1973 MODEL SS / SX

This bulletin contains important information on the 1973 SS-350 and SX-350 which you should be aware of. Recommendations herein should be followed to prevent or remedy possible service complaints on these models.

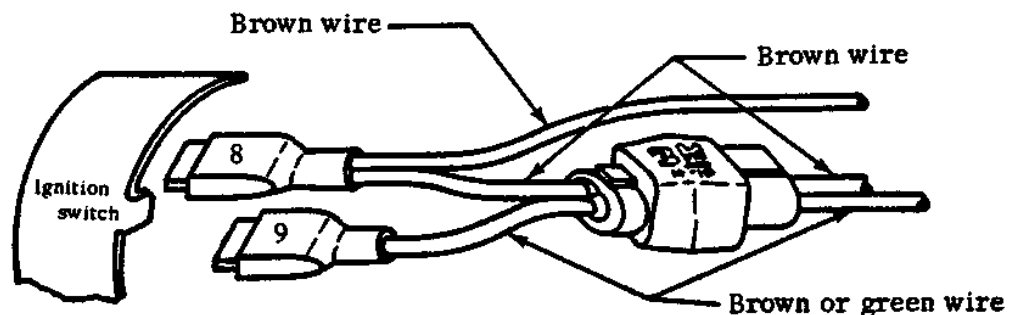
The first 1973 SS-350 motorcycles from 6A10000H3 through 6A10175H3 were produced with a rust preventive finish on the ignition timer cams. This surface finish has resulted in a rapid wear of the point rubbing block. This condition has been corrected on all 1973 SS motorcycles above 6A10175H3 and all 1973 SX motorcycles which have a polished surface on the timer cam which the rubbing block contacts.

If you have experienced difficulty with the breaker point gap closing up on an early 1973 SS with V.I.N. in the above range, we recommend that the cam be polished with a 600 grade sandpaper to remove the rough surface on only the area which the rubbing block rides.
